Technical Service Bulletin: TSB100977

Service Part for LTA Water Pump Reuse

Figure 1. LTA Water Pump With O-ring Visible

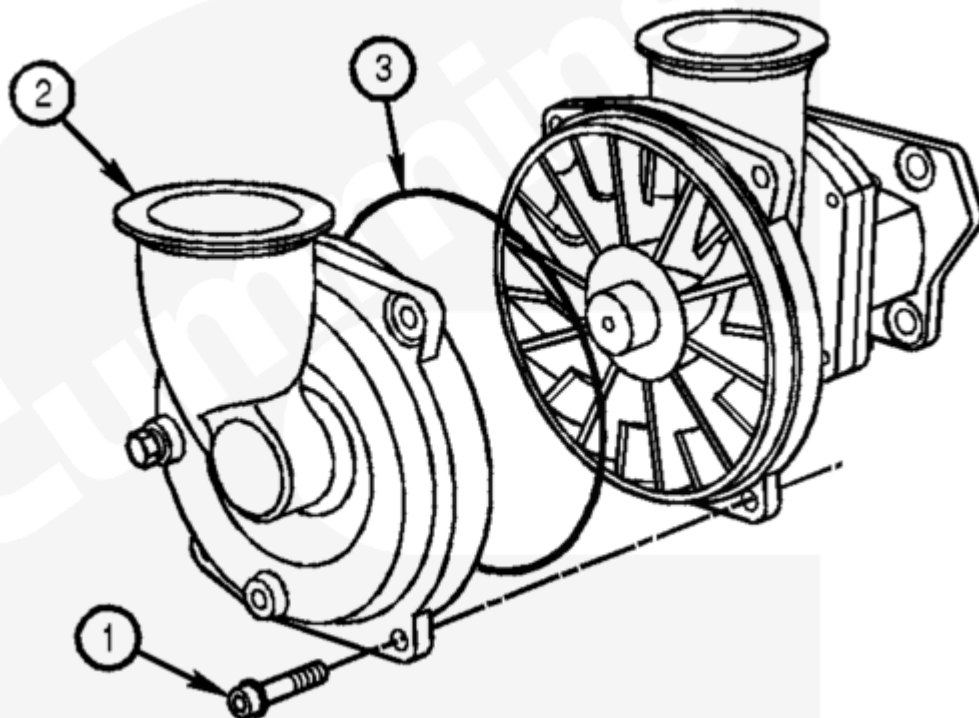
This document announces the service part number used when replacing the o-ring installed inside the low-temperature aftercooler (LTA) water pump for QSK45 and QSK60 engines. Every time the LTA water pump, Part Number 3638083, is disassembled for inspection or repair, the internal o-ring, Part Number 4919909, **must** be replaced. The o-ring, Part Number 4919909, is labeled as (3) in the Figure 1 below.
